### **AMENDMENTS TO THE DRAWINGS**

## **REMARKS**

# Marked-up Version

FIG. 6

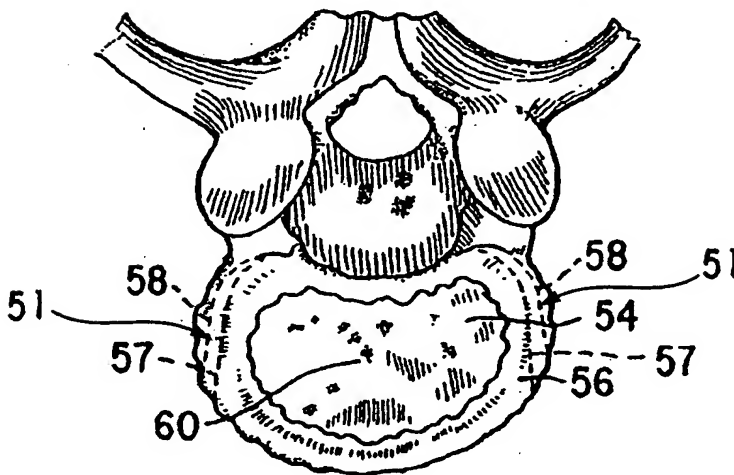
Please amend Fig. 6 as shown in redline in the Marked-Up Version attached.  
A clean copy of the Replacement Drawing is also enclosed.

The specification and drawings are presently amended since it was noted that the numeral 50 was unintentionally used to designate two different elements, and that the lateral sides of the vertebra had inadvertently not been numbered in Fig. 6. The amendment renumbers the lateral sides of the vertebra with numeral 51, and these numerals have been appropriately added to Fig. 6. These amendments are fully supported, for example in the amended paragraphs themselves, on pages 9 and 13.
